3.4 CHILD CARE FITOUT

Figure 3.4.1_DA level 3 plan -child care layout

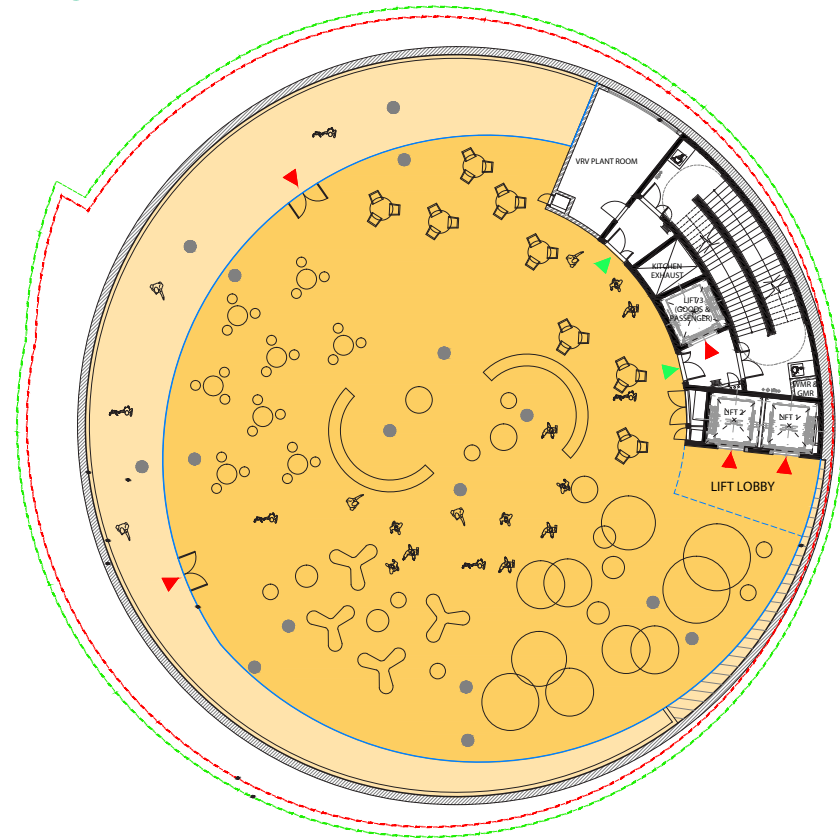
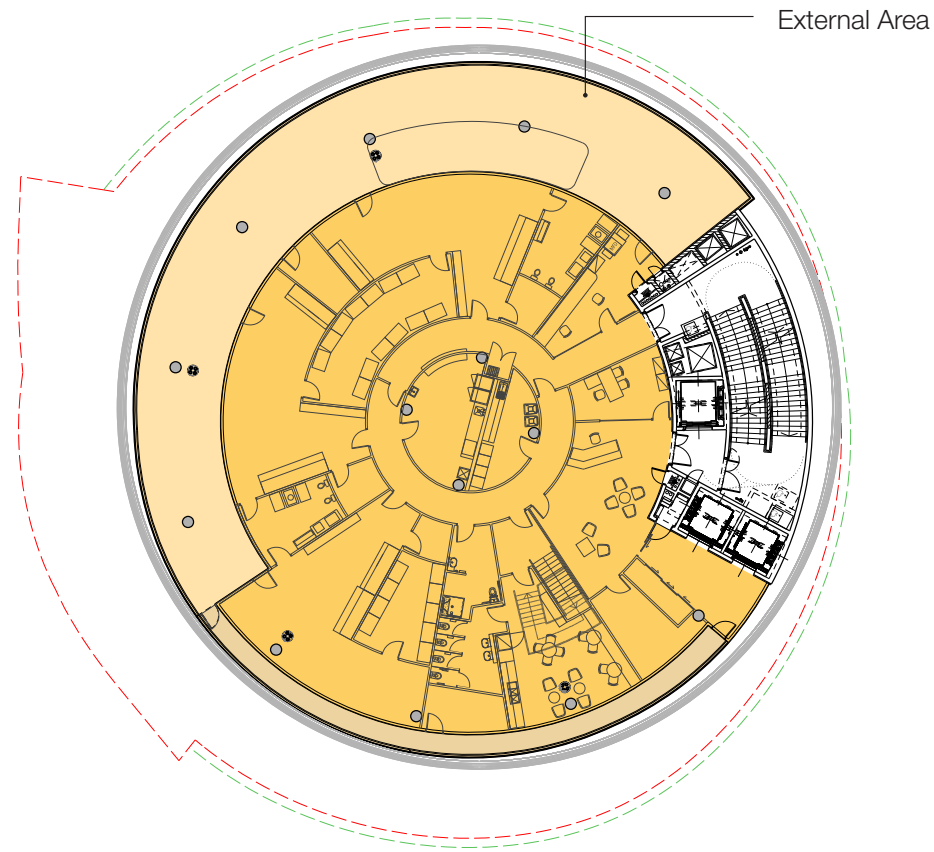
- *At this stage, the amount of outdoor space shown in the DA drawings (239sqm) is only sufficient for a 34-place centre as opposed to 90-place. The glazing line of the building will have to be moved dramatically.*

The external glazing line of both level 3 and 4 have been revised to create a combined unencumbered external area of 685sqm which is suitable for a 90-place centre based on DCP requirement of 7sqm of usable space per child. Level 3 has 268sqm of external space for 36 children (7.44sqm per child). Level 4 has 417sqm of external space for 54 children (7.7sqm per child). Refer to figures 3.4.1, 3.4.2, 3.4.3, and 3.4.4 for a DA/Proposed comparison of levels 3 and 4.

Figure 3.4.5_Levels of direct sun light penetration onto the child care terraces

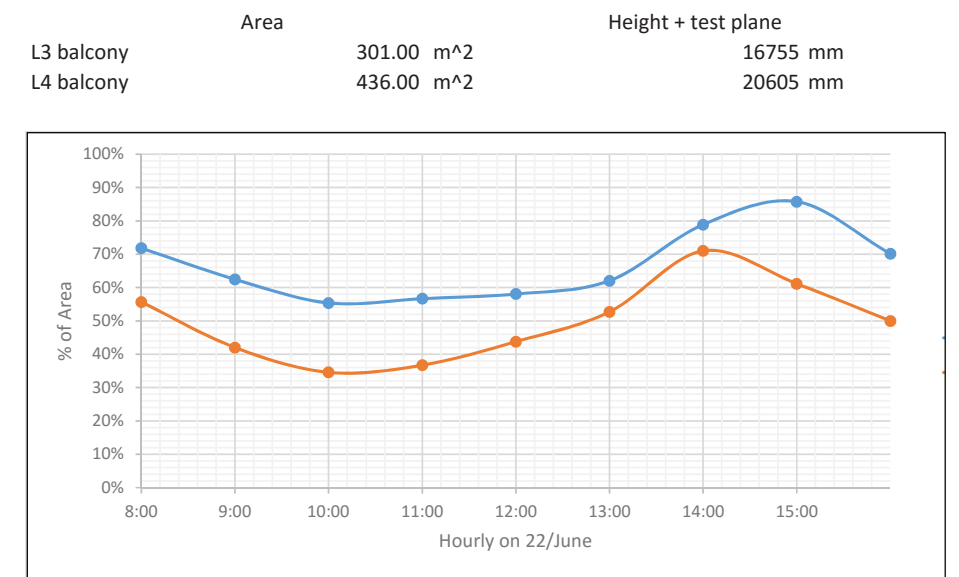
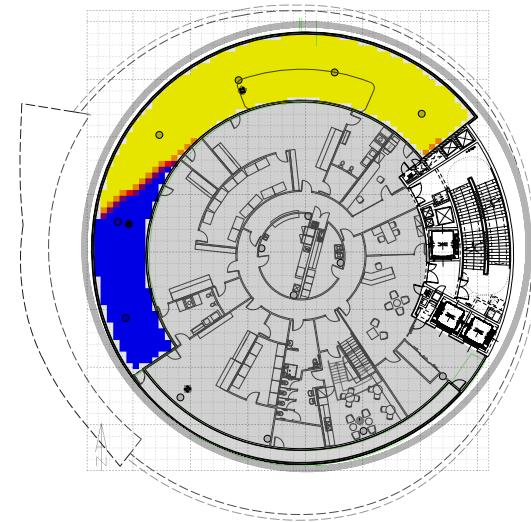
- *The child care centre will require detailed review in relation to acoustic treatments between floors, sufficient and useable outdoor space capable of accreditation, solar access to outdoor space, appointment of child care centre spaces per level, and practicalities of evacuation via fire stairs and lifts.*

Since the lodgment of the DA, extensive solar studies have been undertaken to help refine the size and orientation of the outdoor spaces. The outdoor spaces on both the child care levels receive adequate solar access between 9am and 3pm (and extended hours 8am to 4pm) on the 22nd June as per the Sydney DCP 2012 Section 4.4.4.3. Refer to Figures 3.4.5, 3.4.6 and 3.4.7.

Figure 3.4.1_ The building form has been developed to taper to the solar access plane to minimise the amount of shadowing to The Square.

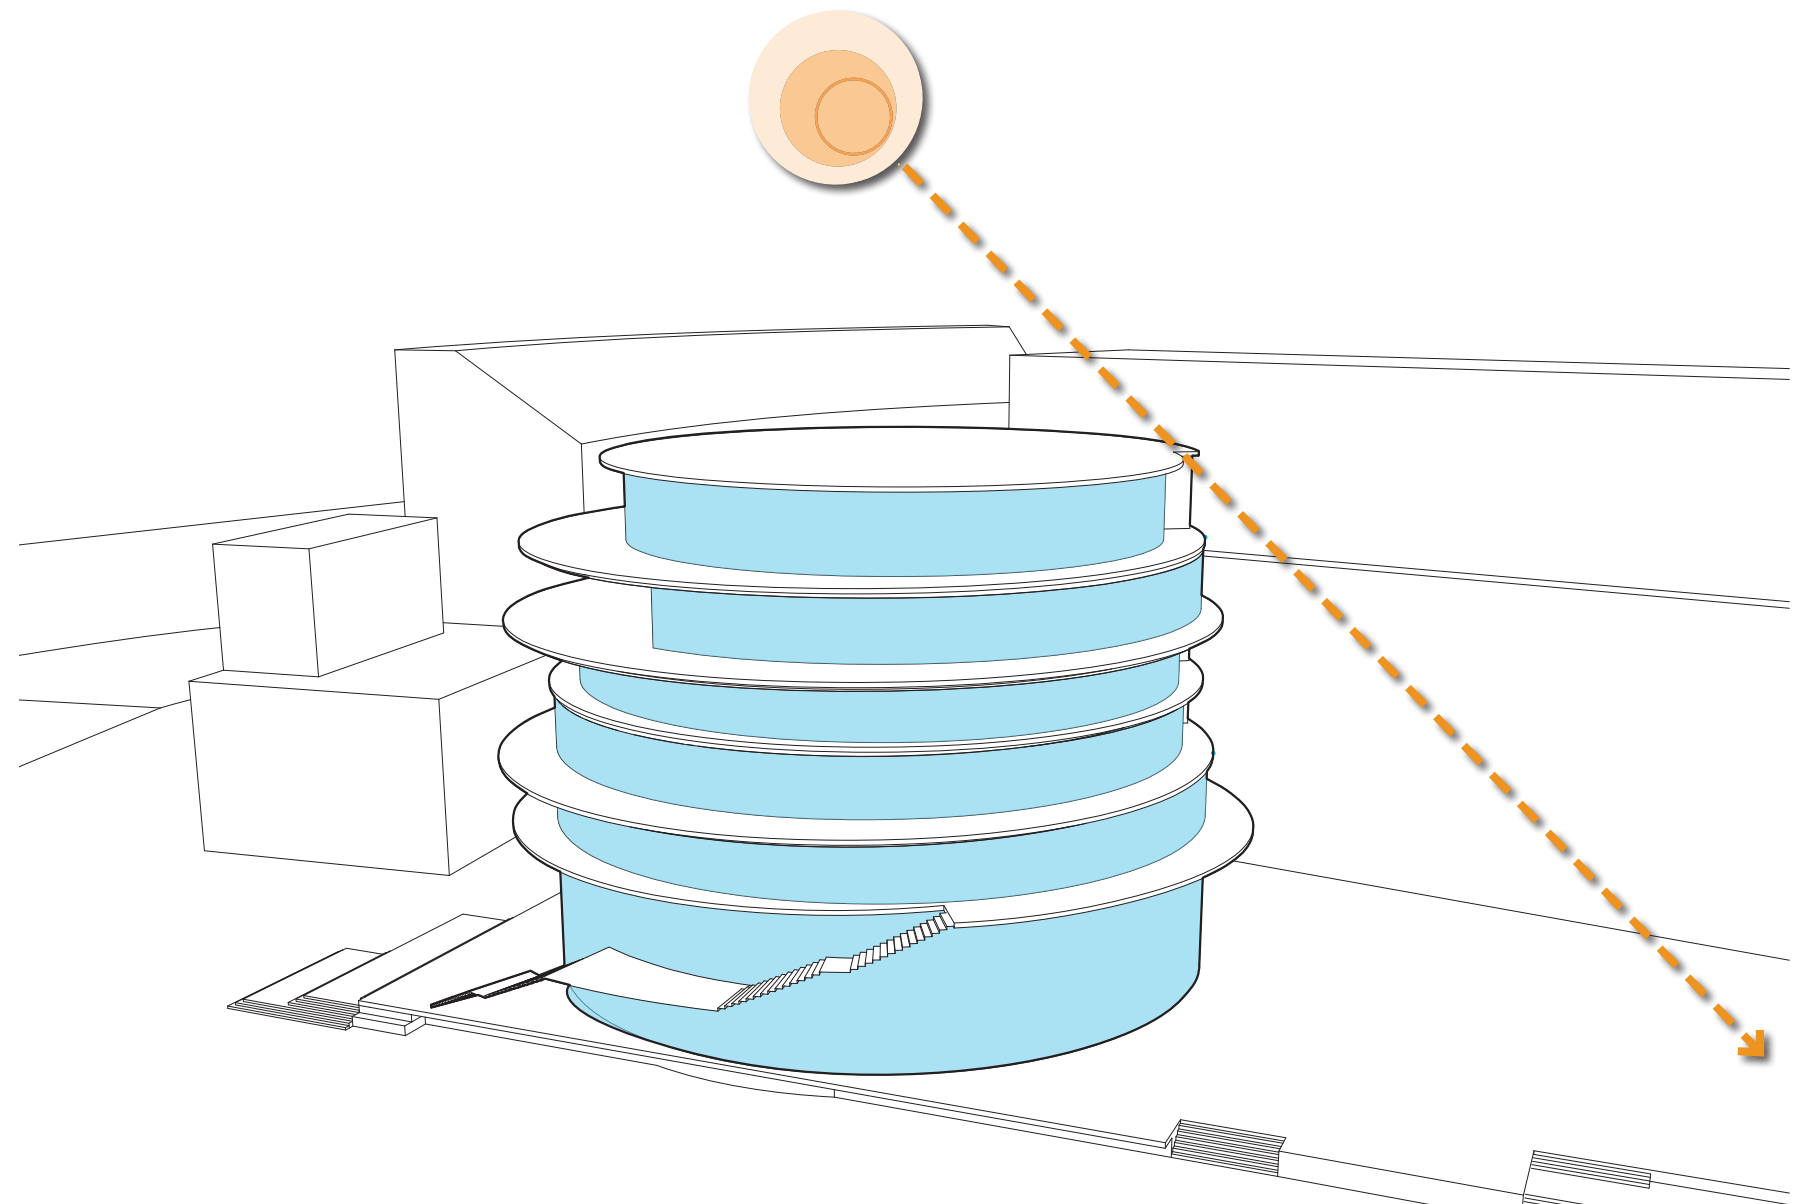
The Authority notes that the height of the proposed building (Darling Exchange) on the North Plot has increased by 5 metres. Any increase in building height should not create additional overshadowing across Haymarket Square during mid-winter. Further modelling is considered necessary in order to ensure solar access across Haymarket Square is maximised, especially the critical 12 midday to 2.00pm lunch time period during mid-winter and to confirm that the built form of the Darling Exchange does not dominate the public square.

The impact from the 5m increase in height has been assessed in great detail as part of the S96 modification to the Concept Plan which has now been approved. The building is entirely within this parameter plan and consistent with the overall parameter plan height control.

The building has been positioned to minimise the shadowing throughout the year. Refer to Appendix B - Shadow Analysis for further information.
